PLANNING & ZONING COMMISSION MEETING

HALE TRAILER SITE PLAN HUXLEY, IOWA

RE: Hale Trailer Site Plan

RE: HUXLEY COMMUNICATIONS SITE PLAN (1955 SE OAK DR.)
SITE PLAN SUBMITTAL COMMENT RESPONSE LETTER
S&A PROJECT NO. 121.0686.01

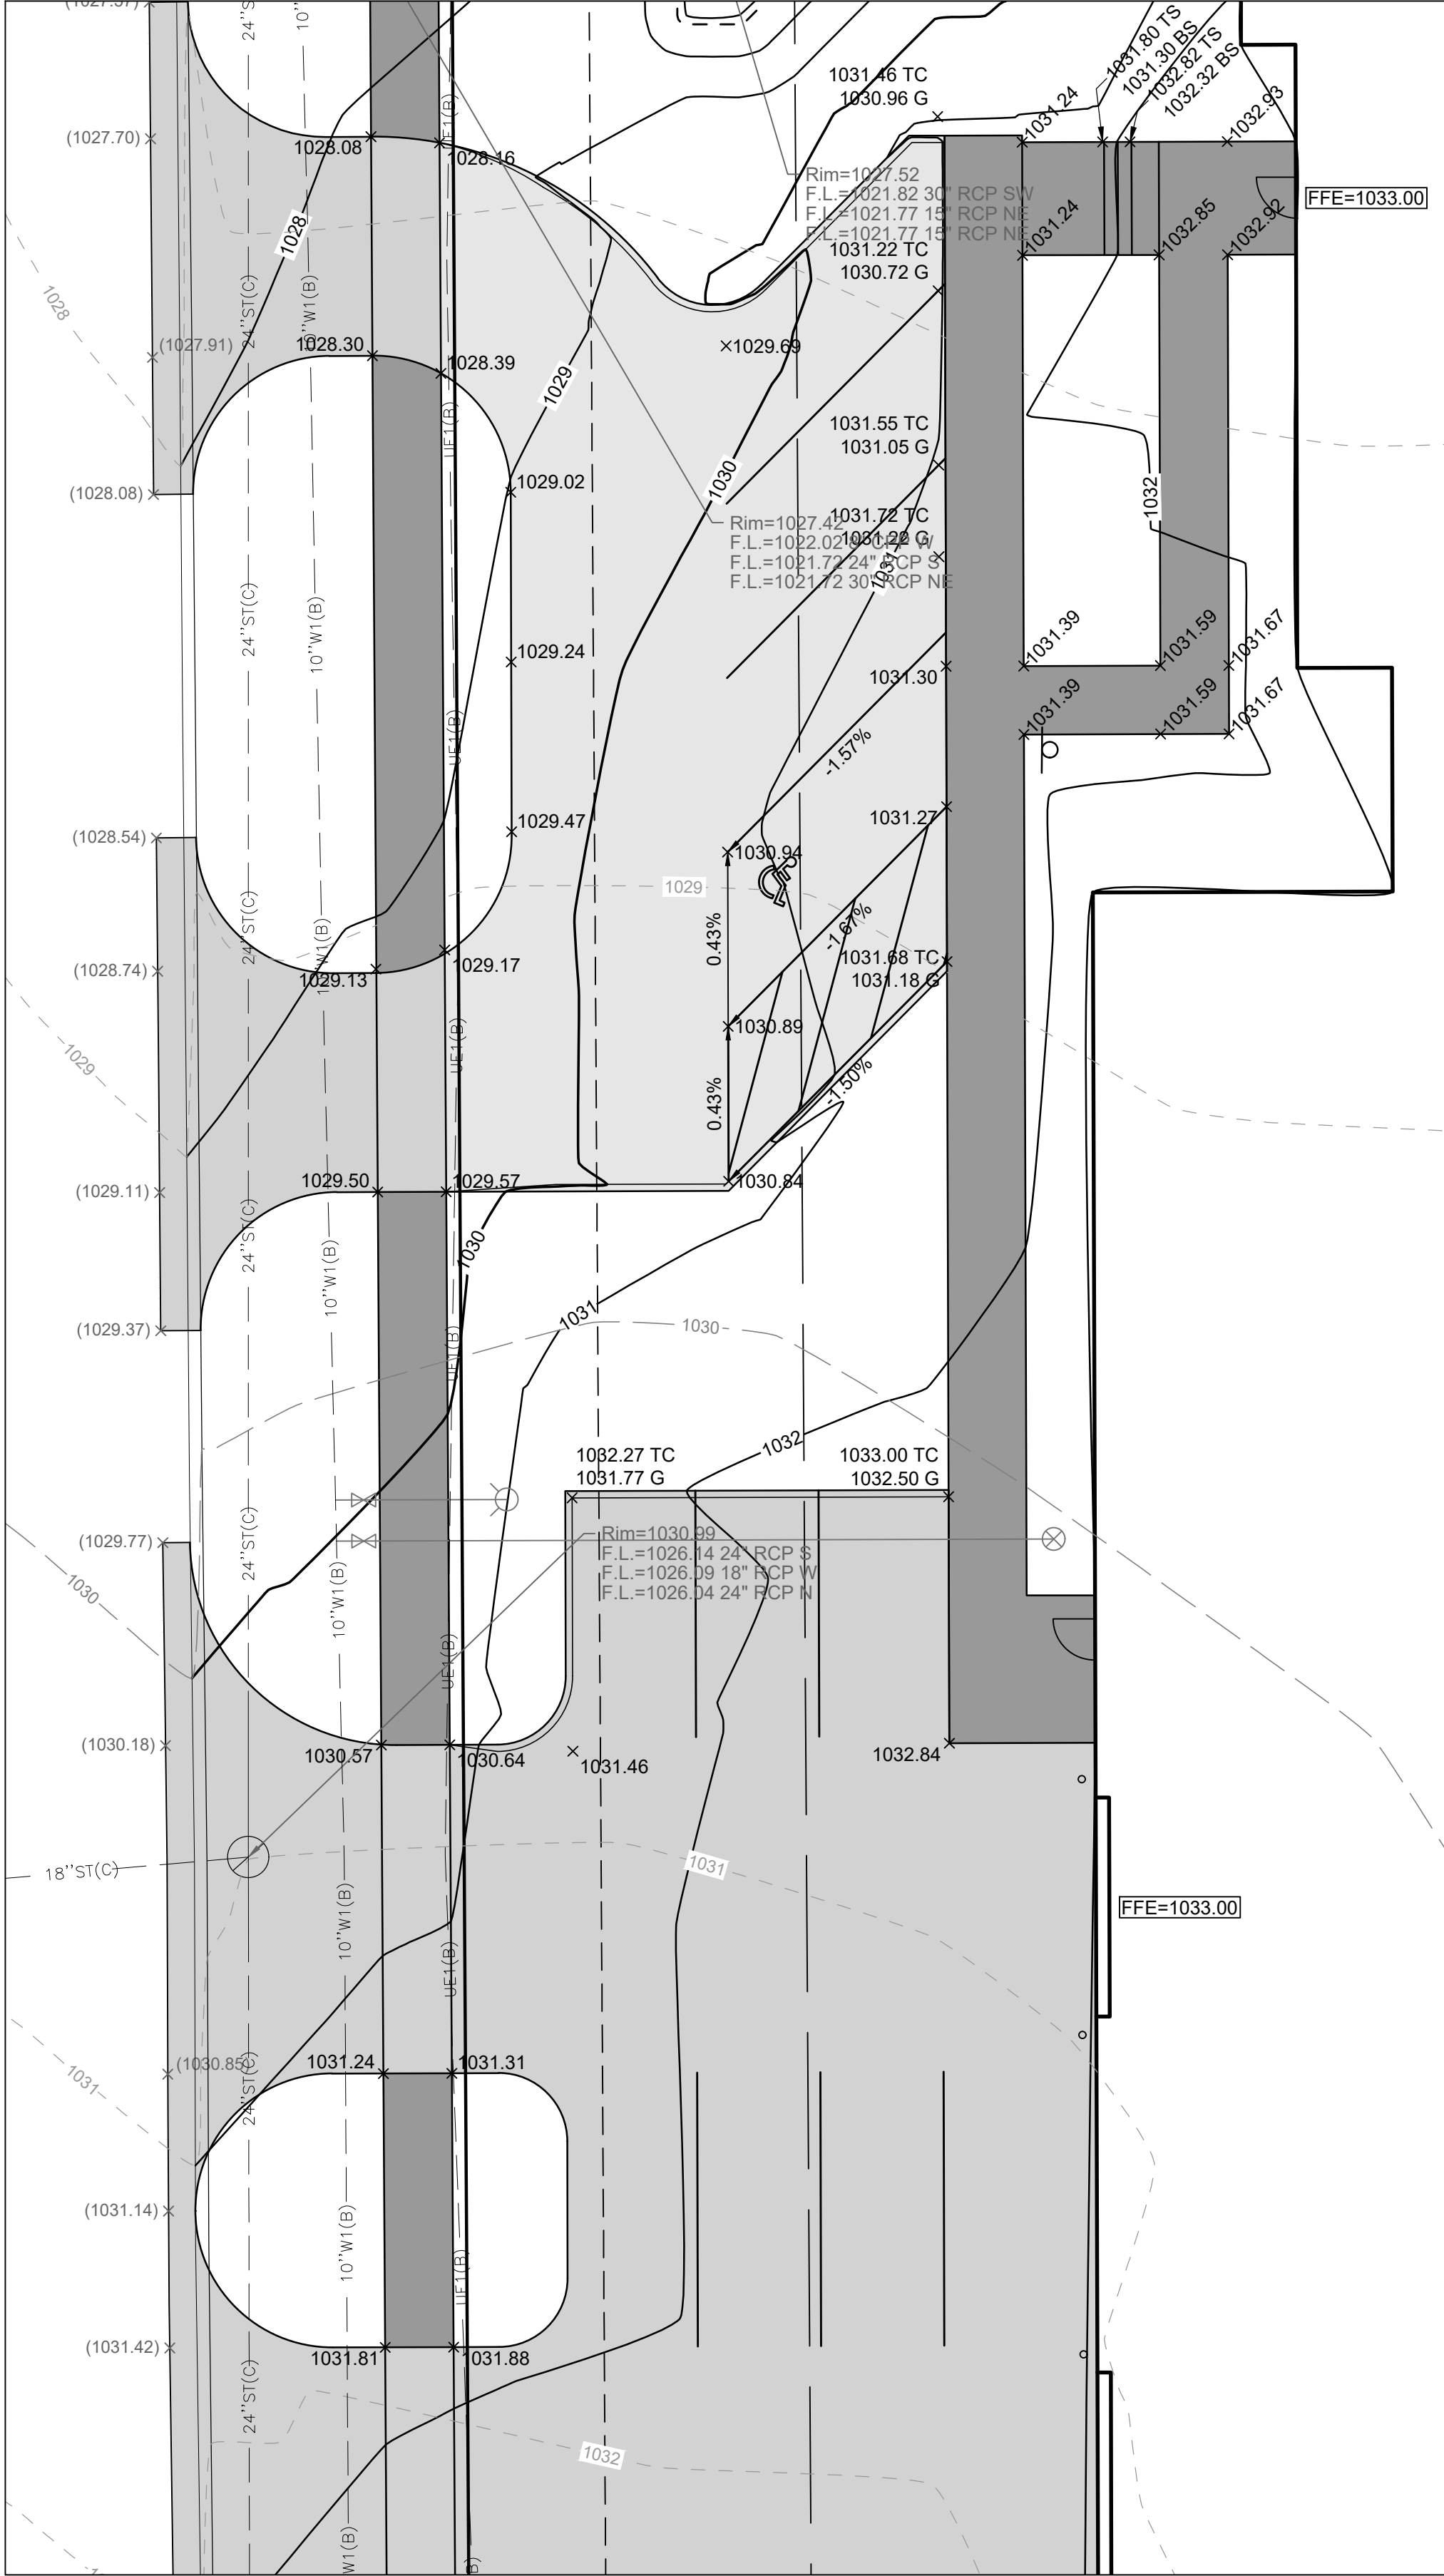
16. The Stormwater Management Plan in the North Pond Report assumed an 8.5-inch orifice. The site plans are showing a 9-inch orifice to be installed. Clarify which size orifice is to be used. **Plan updated to match the 8.5" orifice in the SWMP.**
